**Economic and Social Council**Distr.: General
27 February 2013

Economic Commission for Europe**Inland Transport Committee****World Forum for Harmonization of Vehicle Regulations****Working Party on Passive Safety****Fifty-third session**

Regulation No. 100 (Battery of electric vehicles)**Draft Supplement 3 to the 01 series of amendments****Submitted by the expert from the International Organization of Motor Vehicle Manufacturers***

Figure 2
Single housing:

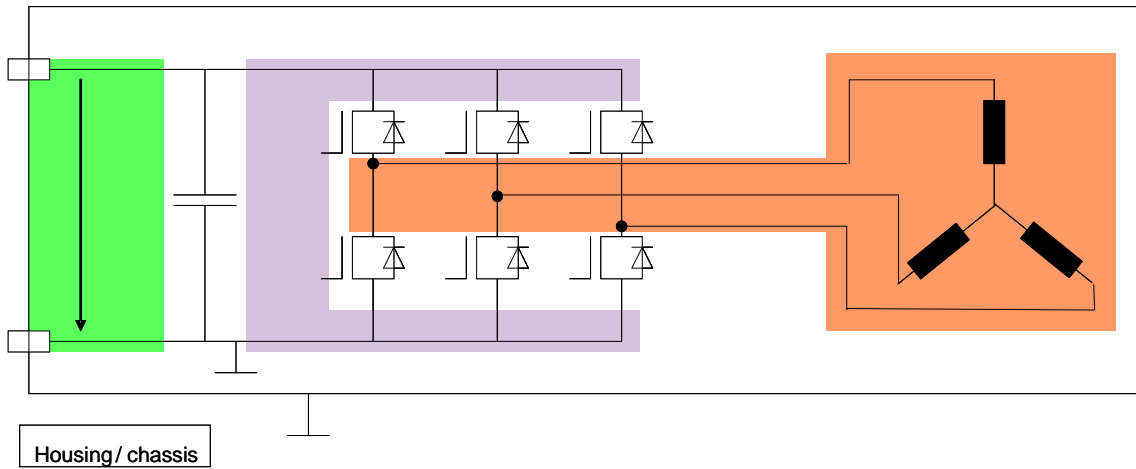
A.C.: a.c. voltages (switched/ sinusoidal), a.c. current (sinusoidal)
 → in **some** operation modes $U > 30$ V a.c between phases,
 but switched d.c. voltage $U < 60$ V d.c between phase and chassis

D.C. voltage, switched current (ripple)

D.C.: d.c. voltage, d.c. current → $U < 60$ V d.c.

10. According to the current high voltage definition of UN Regulation No. 100, there is AC high voltage in the system but no DC high voltage. The AC high voltage is located

between the phases of the electric motor. However, the rest of the system, as well as between the phase and chassis of the electric motor is considered as DC low voltage. Today, the working voltage of the circuit is defined as the highest voltage between any two conductive parts. Accordingly, the working voltage of a 48 V system is high voltage, so the whole 48 V system would be classified as high voltage.

Figure 3
Two housings:

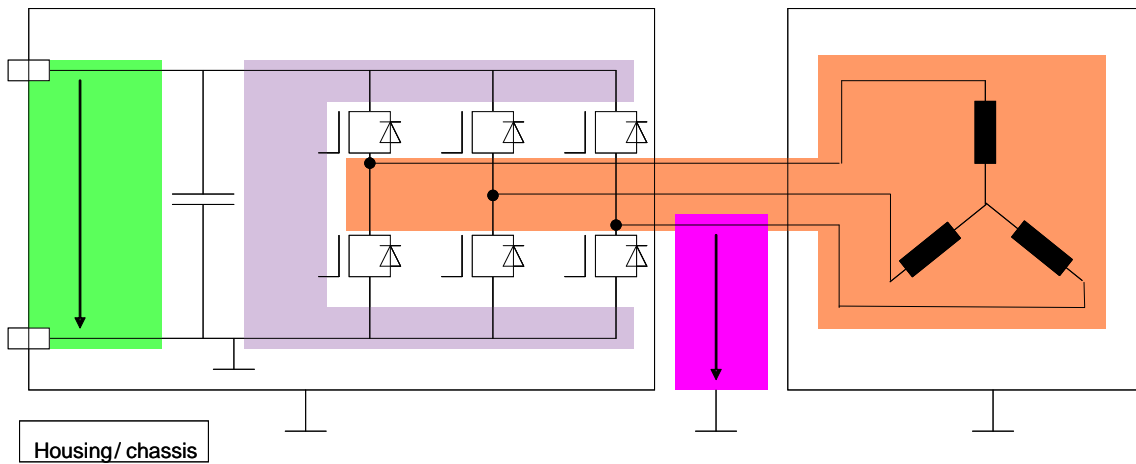
A.C. a.c. voltages (switched/ sinusoidal), a.c. current (sinusoidal)
 → in **some** operation modes $U > 30$ V a.c between phases,
 but switched d.c. voltage $U < 60$ V d.c between phase and chassis

D.C. voltage, switched current (ripple)

D.C. voltage switched

D.C. d.c. voltage, d.c. current → $U < 60$ V d.c.

Figure 4

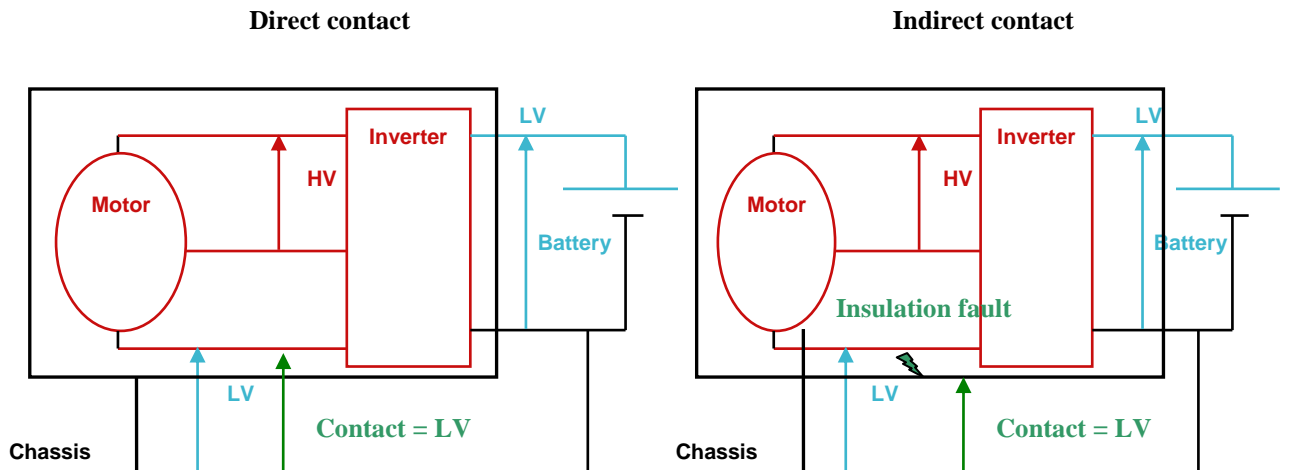
15. In single fault conditions, there is no risk of electric shock by touching one AC phase and the chassis. Neither in direct nor indirect contact will the touch voltage be high voltage. In all cases, customers are protected, as there is only low voltage, independent of isolation resistance. Therefore, the fact that there is no isolation resistance on the system is not a safety issue for a 48 V system.
